RE: HYDRAULIC ANALYSIS  
VYNE ADDITION, WICHITA, KANSAS

**SUBDIVISION COMMITTEE  
METROPOLITAN AREA PLANNING COMMISSION**

**STAFF REPORT  
(Preliminary Plat)**

- CASE NUMBER:** S/D 94-68 VYNE ADDITION
- OWNER/APPLICANT:** J. William Owen and Charles Aikins, 7701 E. Kellogg - Suite 780, Wichita, KS 67207
- CONTRACT PURCHASER:** Jim Lew, 4711 Arbour, Wichita, KS 67218

**VICINITY MAP:**

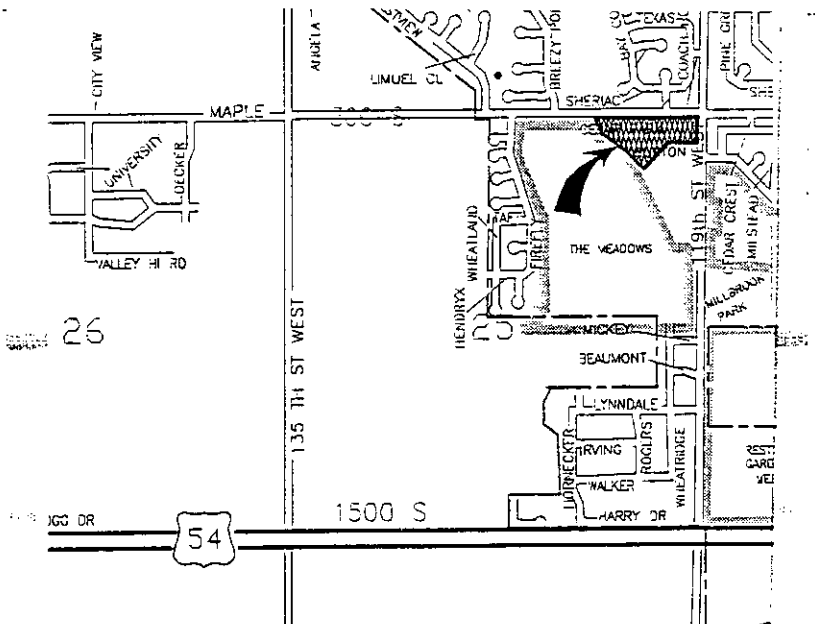
- A. Approval of this plat shall be subject to approval of the associated zone change (Z-3143) and any conditions of such approval.
- B. The applicant shall guarantee the extension of sanitary sewer to serve the lots being platted.

- C. The applicant shall guarantee the extension of City water to serve the lots being platted. Specifically, the applicant shall submit a guarantee for the extension of water in 119th Street West adjacent to this site.

- D. The applicant shall guarantee any drainage improvements required by the platting of this property.
- E. Based on the anticipated zoning for this site (involving nearly 11 acres of office and multi-family development), Traffic Engineering needs to indicate any traffic improvements that should be guaranteed by this Addition.

- G. For office zoning, the Subdivision Regulations require the platting of 35-foot building setbacks from adjacent arterials. Lot 1 shall therefore plat 35-foot building setbacks to both Maple and 119th Street West.

For Lot 2, while the zoning ordinance indicates 20-foot building setbacks for "B" or multi-family zoning and the Subdivision Regulations have no specific standards beyond the typical 25-foot building setback for residential type uses, it is recommended that this lot also show a 35-foot building setback to Maple. Under platting, setbacks may be established other than those noted on the zoning ordinance. For this specific site, the presence of residential uses (homes) immediately across Maple should require a reasonable degree of buffering. Any setback less than 35 feet would not provide such buffering.
- H. On the final plat, at least 100 feet of complete access control shall be shown on Lot 1 to both Maple and 119th Street West from this lot's northeast corner.

- L. If any portion of Reserve A is involved in floodway, the limits of such floodway shall be shown, the Reserve uses shall note such use, and the platting text shall reference the standard floodway language.

- M. If this plat requires the platting of minimum building pad elevations such elevations shall be noted both on the face of the plat and in the platting text in both Mean Sea Level and City Datum. It shall also be noted if the elevation is for the lowest opening or floor level. Also, both on-site and off-site benchmarks shall be indicated.

- N. Any required off-site utility easements such as along the southeast line of Lot 2 shall be created by separate instrument and submitted to Planning for processing with the final plat tracing.

- P. As noted by the Comprehensive Plan, a recreational corridor is indicated along the western edge of this site or along the stream adjacent to the plat. Prior to submitting the final plat, the applicant shall meet with Planning Department staff to determine if and how such corridor can be indicated on this plat.

VICINITY MAP:

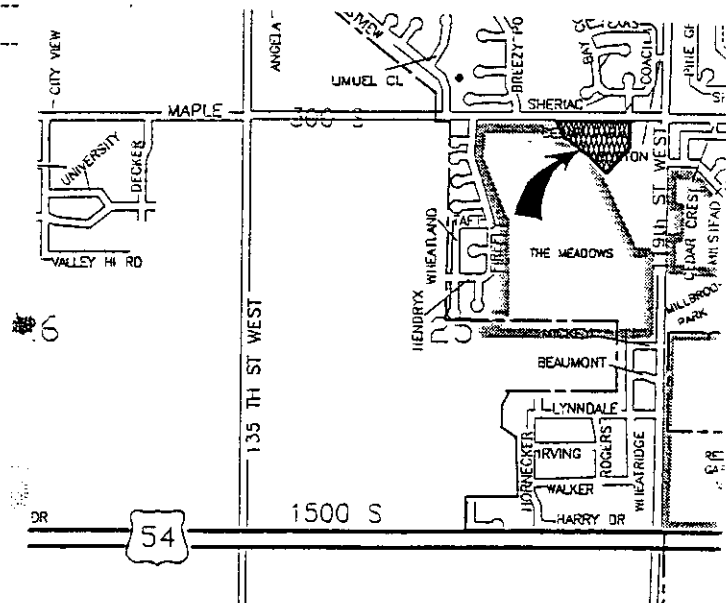
- A. The applicant shall guarantee the extension of sanitary sewer to serve the lots being plated.
- B. The applicant shall guarantee any drainage improvements required by the platting of this property. These improvements may be done at the time of site development.

- C. Traffic Engineering needs to indicate what traffic improvements need to be provided to serve this site.
- D. If improvements are guaranteed by petition, a notarized certificate listing the petitions shall be submitted to the Planning Department for recording.

- E. Provisions shall be made for ownership and maintenance of the proposed reserves. The applicant shall either form a lot owners' association prior to recording the plat or shall submit a covenant stating when the association will be formed, when the reserves will be deeded to the association and who is to own and maintain the reserves prior to the association taking over those responsibilities. Even if the Reserve (A) is to be owned only by the owner of Lot 1, such covenant shall still be provided.

- F. For those reserves being plated for drainage purposes, the required covenant which provides for ownership and maintenance of the reserves shall grant, to the City, the authority to maintain the drainage reserves in the event the owner(s) fail to do so. The covenant shall provide for the cost of such maintenance to be charged back to the owner(s) by a method similar to special assessments.

- K. As indicated by KG&E-Gas, a six-inch gas line is near this site and any relocation of the line made necessary by this site's development shall be at the expense of the property owner.

- L. On the final plat tracing, the MAPC signature block shall be amended to indicate John W. McKay, Jr. as Chairman.
- M. The indicated 10-foot, off-site utility by separate instrument shall be submitted with the final plat tracing to Planning for processing.

- N. Since this plat is not likely to be completed before 1995, dates on the final plat tracing should be adjusted accordingly.
- O. Perimeter closure computations shall be submitted with the final plat tracing. Section 5-101(c).

- P. Recording of the plat within 30 days after approval by the City Council.
- Q. The representative from the City Engineer's office should be prepared to comment on the status of the applicant's drainage plan. Specifically, is the minimum building pad correct, are the boundaries of the floodway adequate and are any drainage guarantees required with the platting of this property?
